Re: Supplemental Photos, Marlboro Apartments, 1031 Marlborough, Detroit, MI

CONTINUATION/AMENDMENT SHEET
Historic Preservation
Certification Application

**MARLBORO APARTMENTS
BUILDING RENOVATION**

REVISIONS THIS SHEET

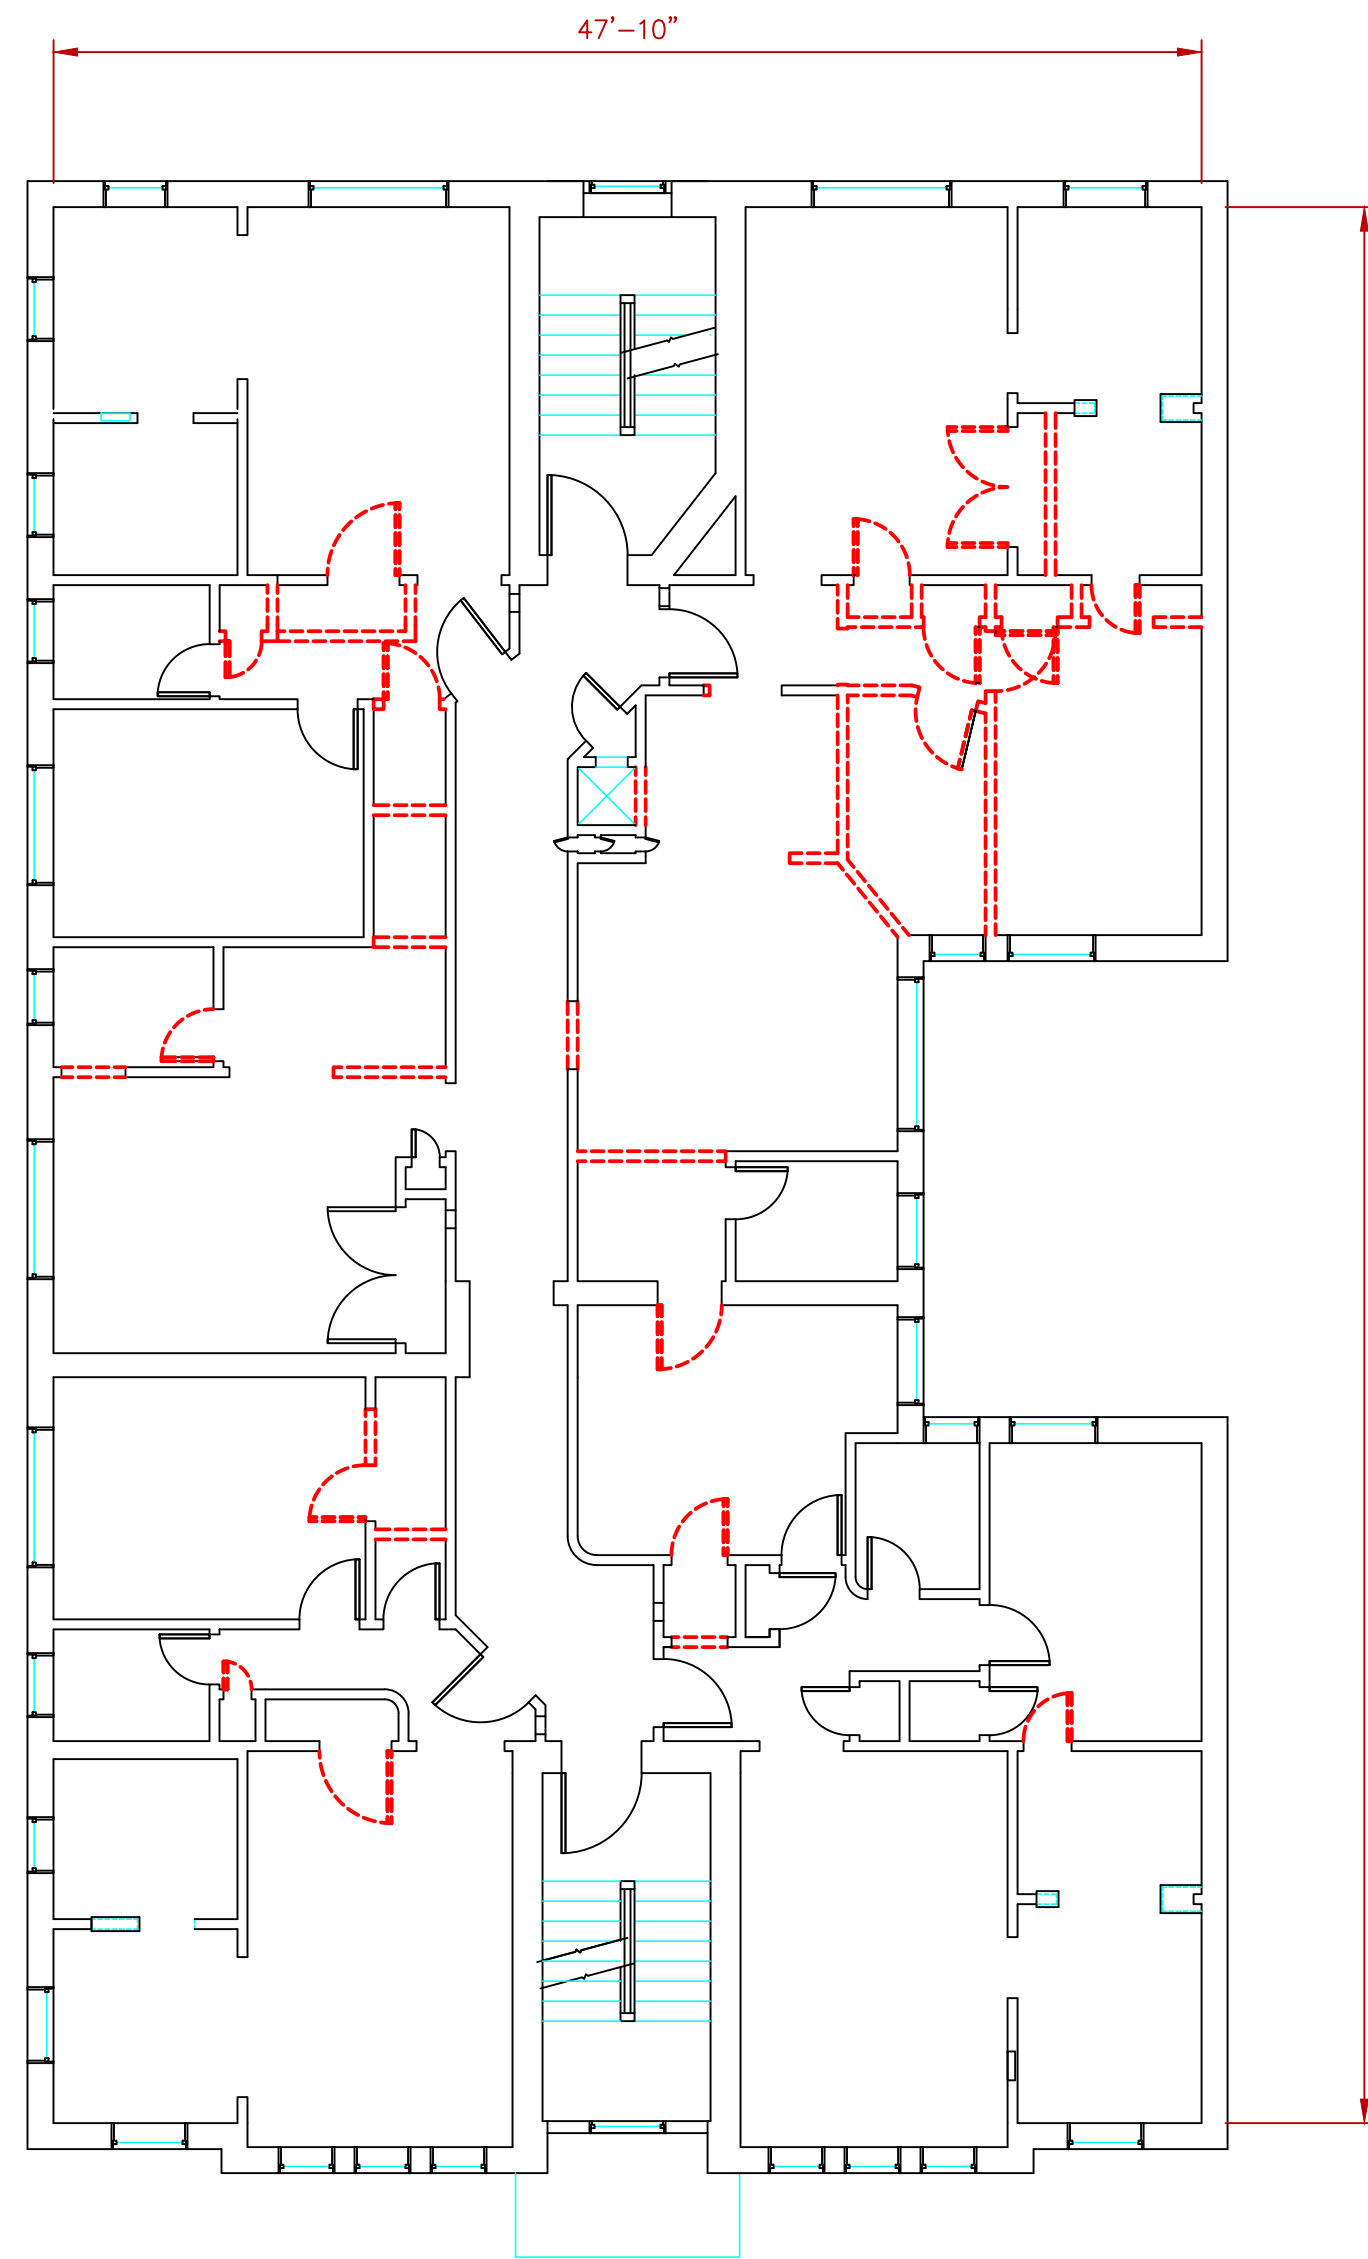
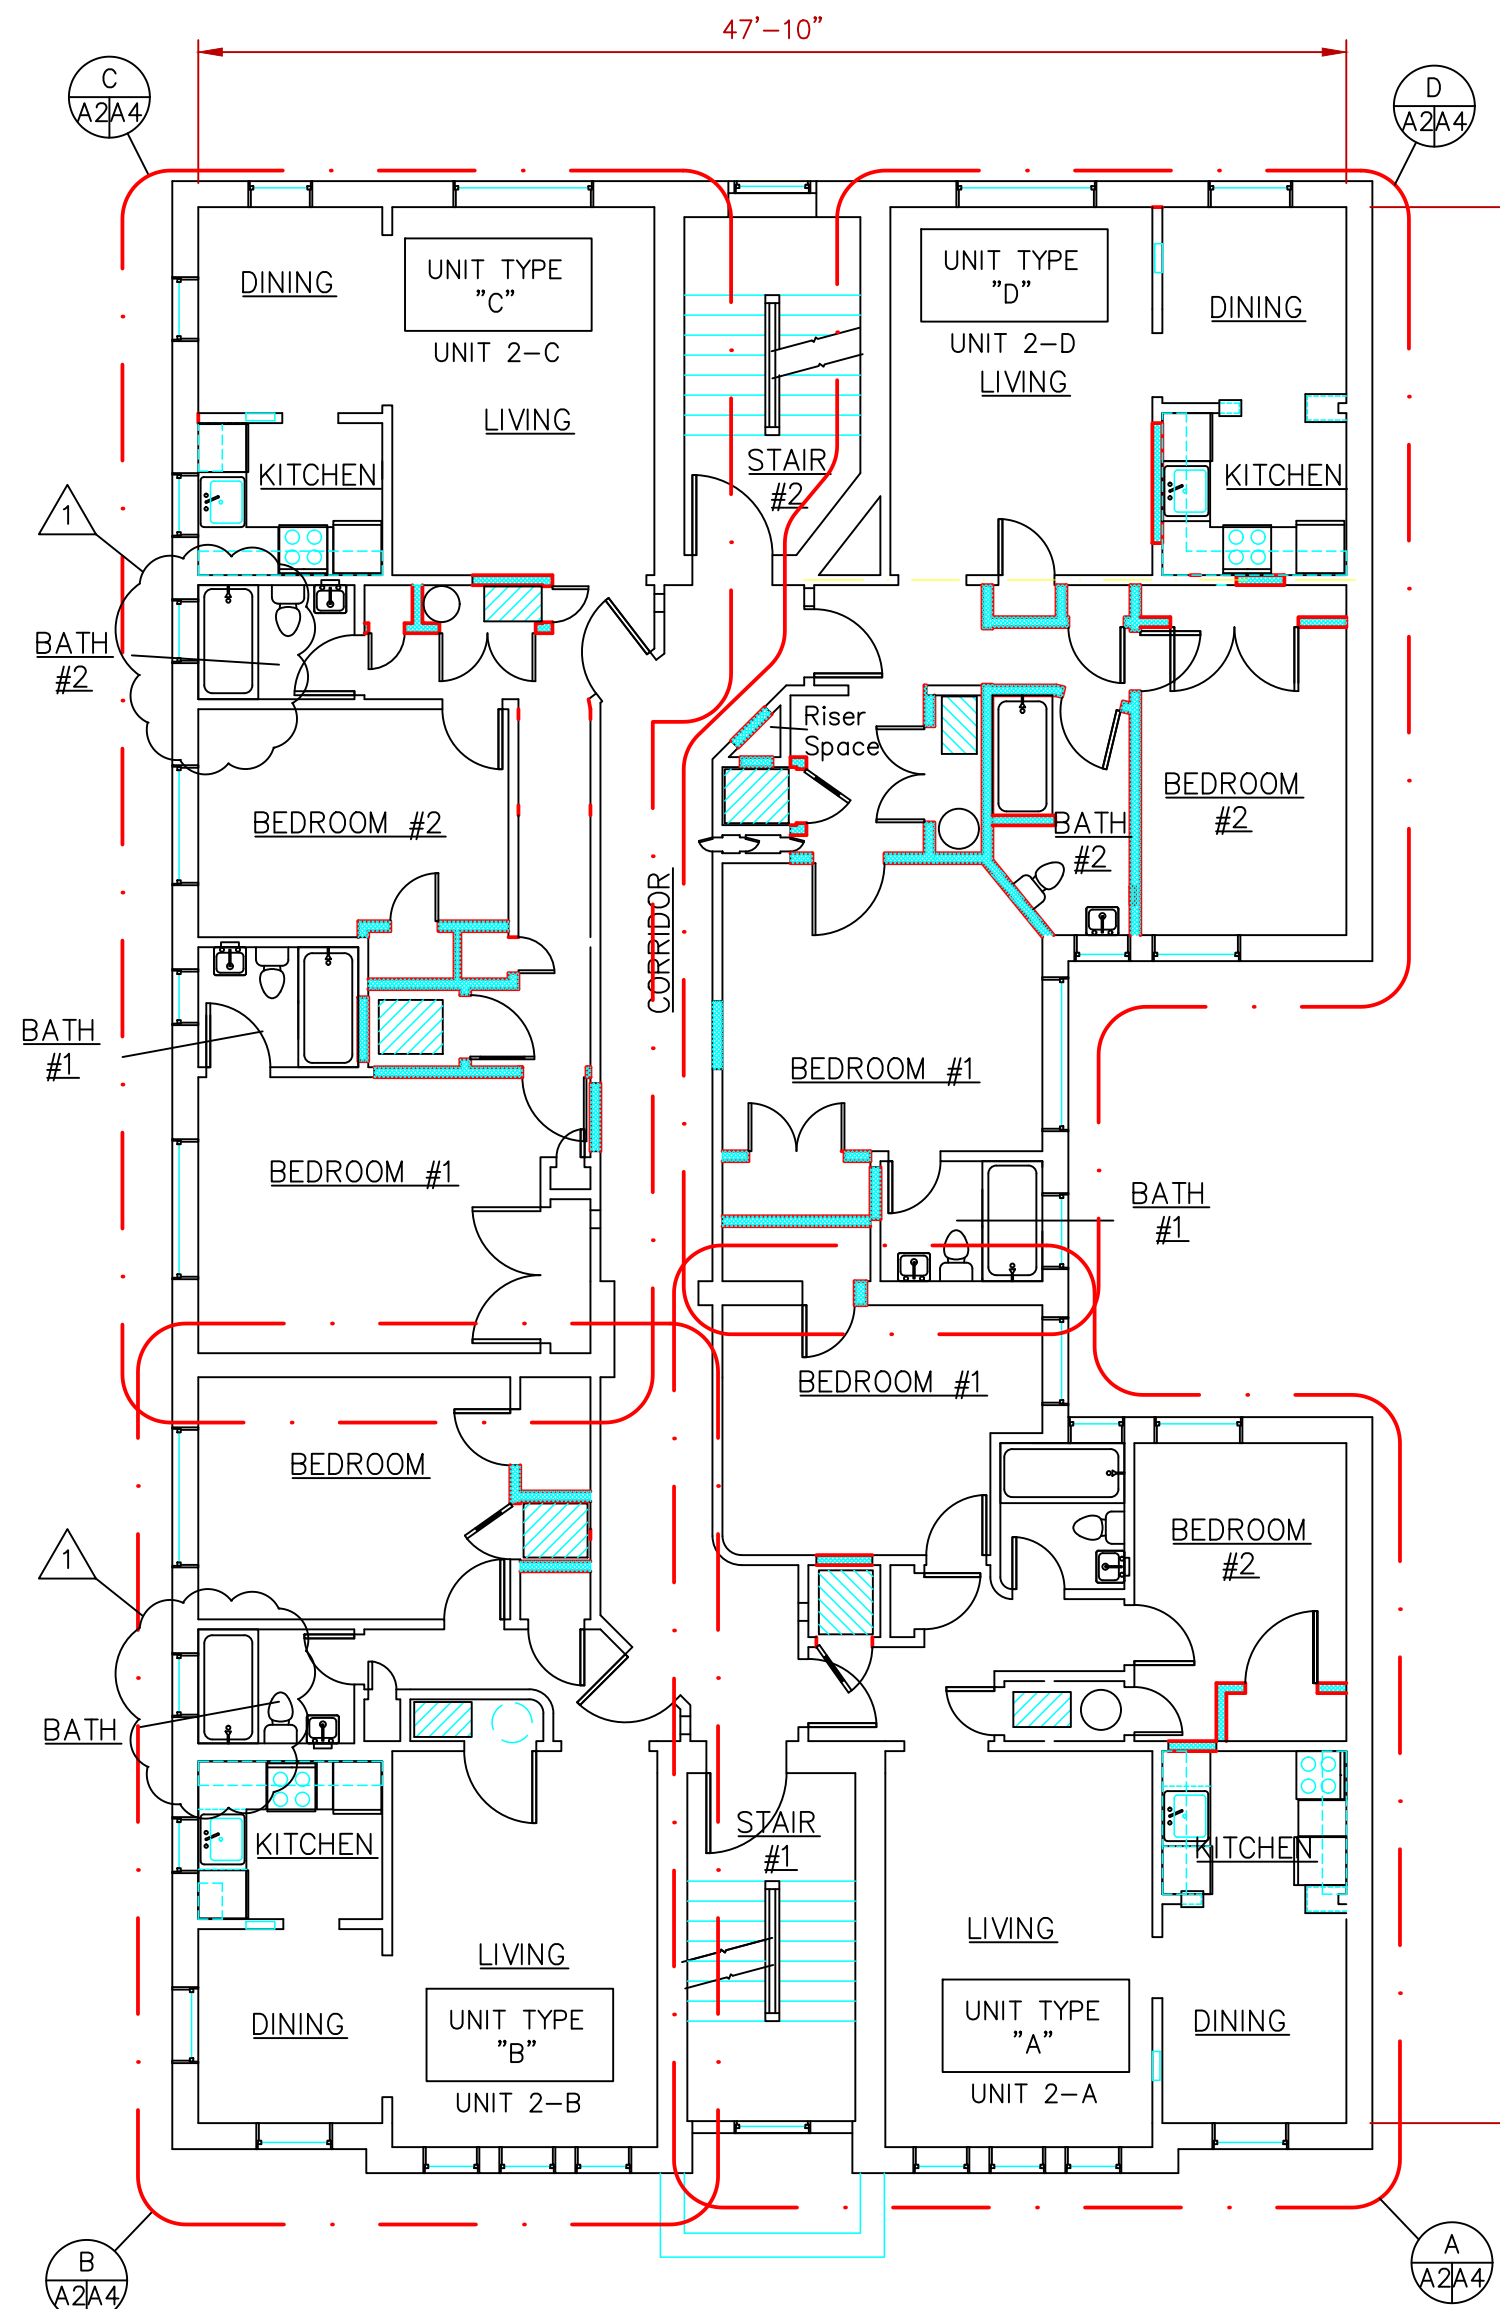
△ REVISED TUB/SHOWER UNIT SIZES
